## MEMORANDUM

To: Development Review Board  
From: Mary O'Neil, AICP, Senior Planner  
Date: September 16, 2014  
RE: ZP15-0249CA/CU; 19 Fletcher Place

**Request:** Convert 2 unit apartment building to 3 units. Utilize existing 2<sup>nd</sup> curb cut, formalize two parking spaces. Add split rail fencing as parking barrier. Remove sidewalk abutting original driveway; add three egress windows on 1<sup>st</sup> and 2<sup>nd</sup> floor for a total of six new windows.

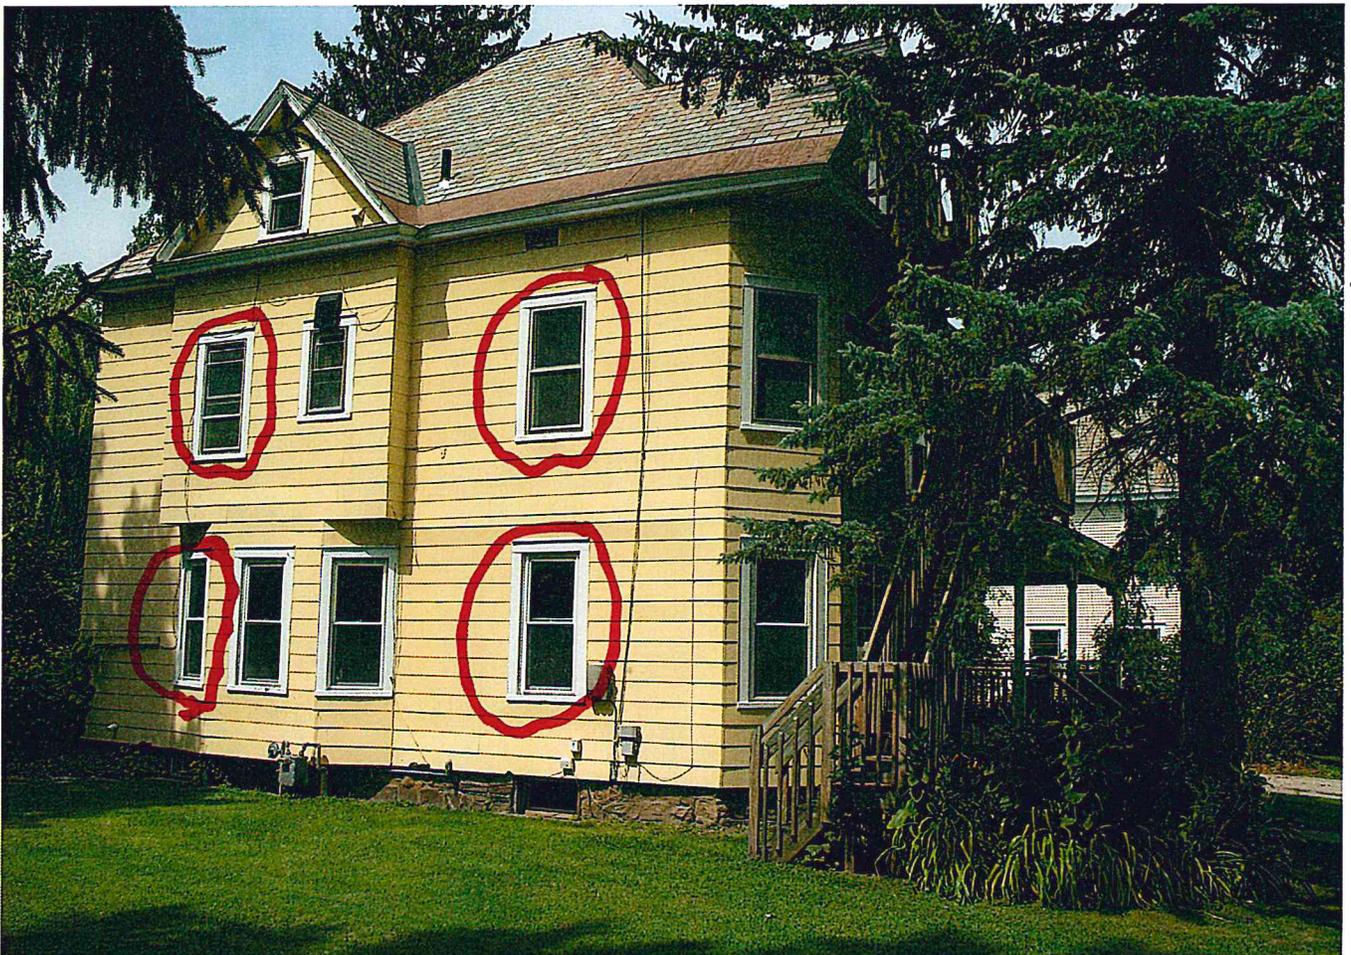
1. The applicant is responsible for securing a state wastewater permit, if required.
2. **Prior to release of the zoning permit**, an Erosion Prevention and Sediment Control Plan must be approved by the City stormwater engineer.
3. The area of walkway will be returned to grass.
4. Replacement windows may operate differently than existing; however a strong meeting rail shall be applied on the exterior to visually replicate a double hung window when closed.

5. The applicant will provide a method of edging the gravel parking area so as to prevent parking lot creep. This shall be provided for staff review and approval prior to release of the zoning permit.
6. All units shall be registered with Minimum Housing, as appropriate.
7. Standard permit conditions 1-15.

LENDY II LLC  
19 Fletcher Pl.

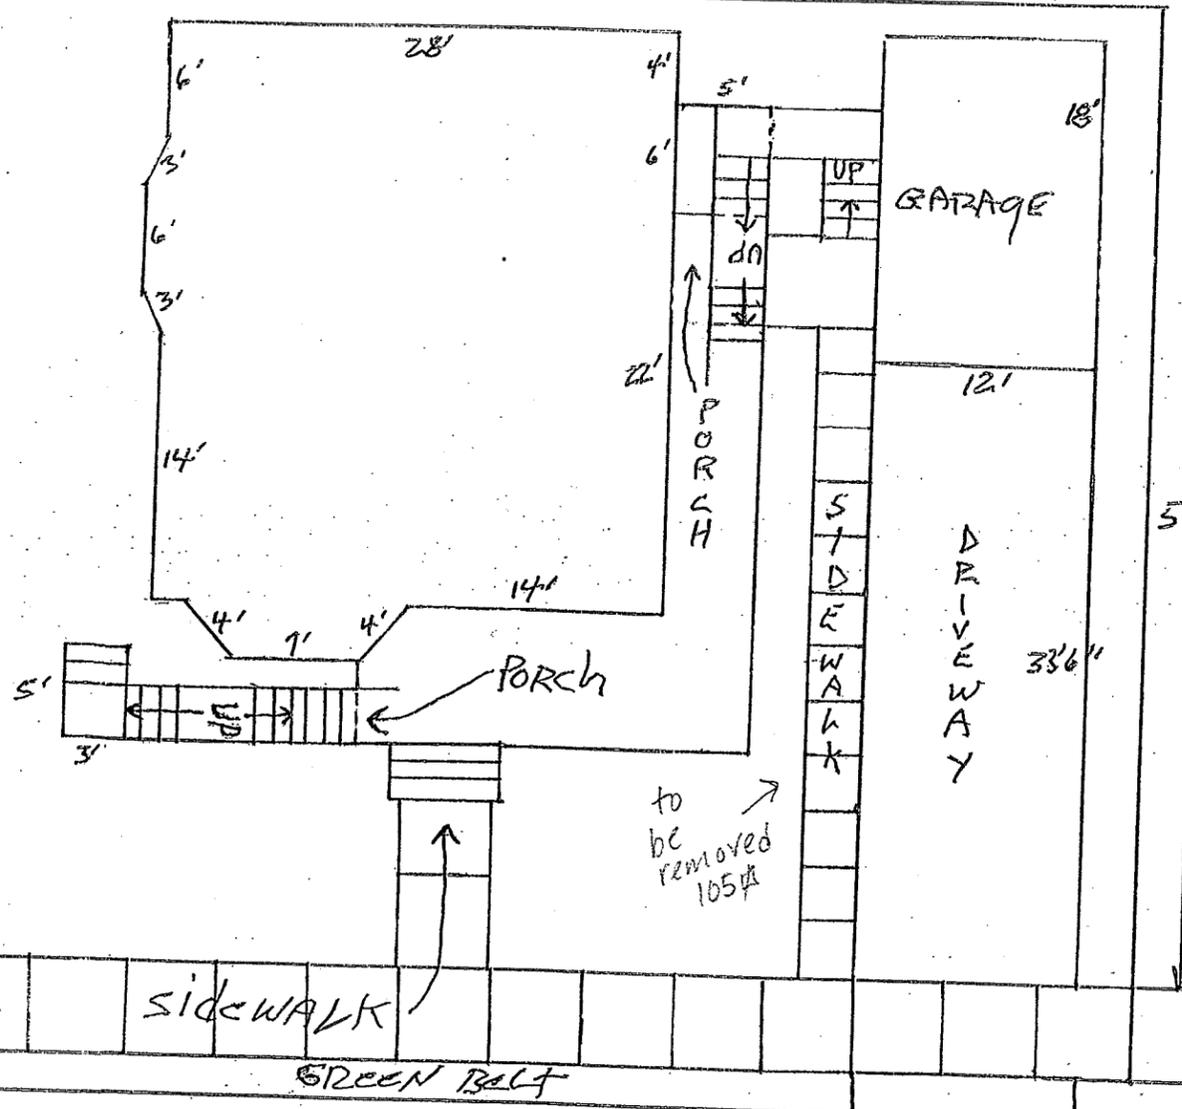
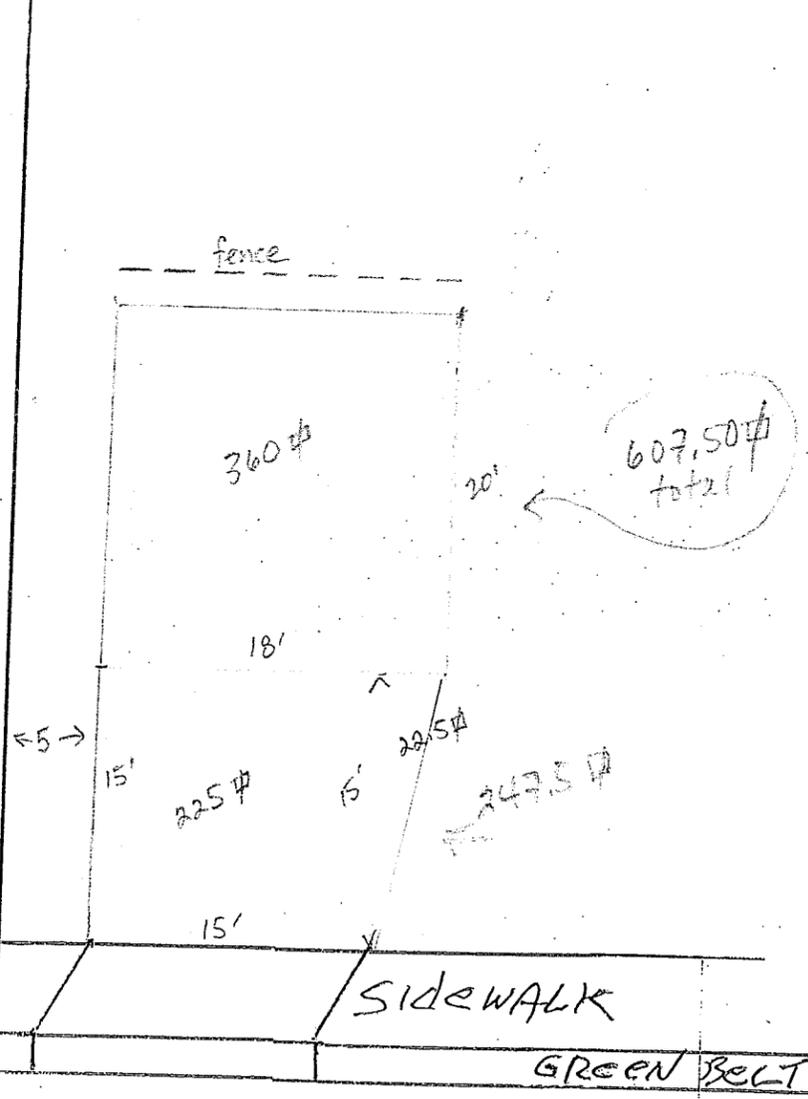
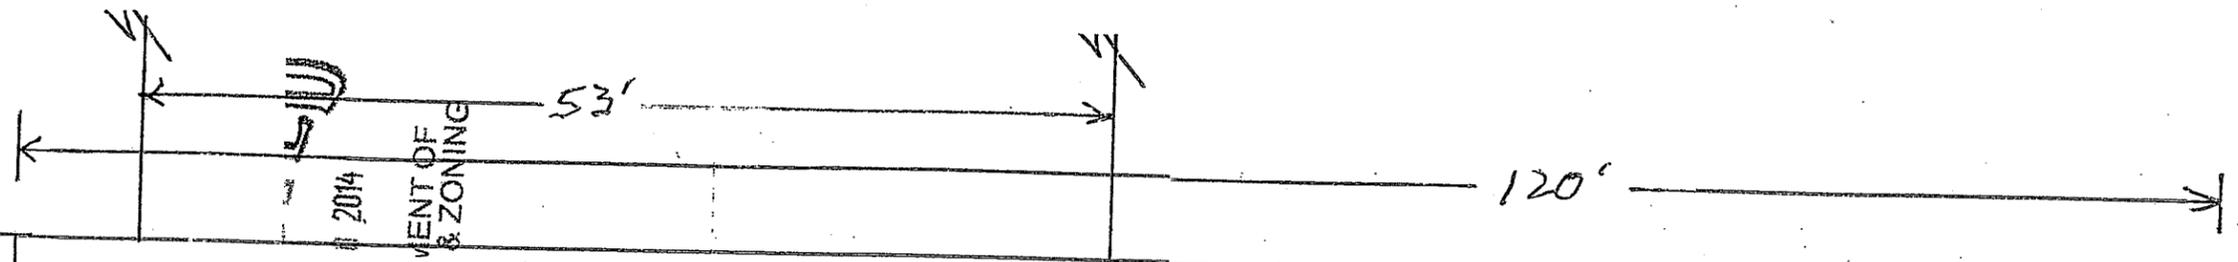
One parking space is proposed for the existing driveway; two parking spaces are proposed to be formalized in the area where a one car parking space has been located. As

the front yard setback is met for the improved parking area, required parking has been provided.

Multi – unit attached dwelling units. Shared Use districts, 1 parking space / unit.  
3 units = 3 parking spaces. One parking space is provided in the driveway; 2 spaces are illustrated on an improved parking area south of the structure; accessible by an existing curb cut. **Affirmative finding** if front yard setback met.
